JUSTIFICATION FOR CHANGE

PROJECT: Senior Citizen Center Construction

CONTRACT NO. 227-2014

CHANGE ORDER: 7

CLIENT: LFUCG
PROJECT: Senior Center
SUBJECT: Undercut

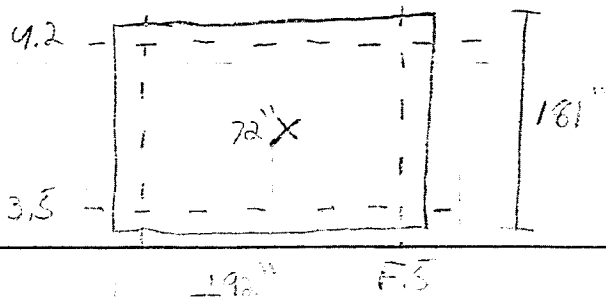
Cal. Footings @ C.L. F.5/3.5 + 4.2
+ E.9/3.5 + 4.2
flow carry-over
@ 915 PM. Elevate Pier Footings

- Bearing observation revealed top soil.
- Undercut to 24" below.
soil tan to grey, saturated silty clay. -1000 psf.
- Undercut to 5' below bearing
tan to grey, saturated silty clay
w/ large void located @
Top of Rock.
- Undercut to expose apparent
bedrock.

Total depth \approx 6' below bearing.
total volume \approx 192" x 181" x 72"
E.9 53.63 yd³

Flowable Fill placed.
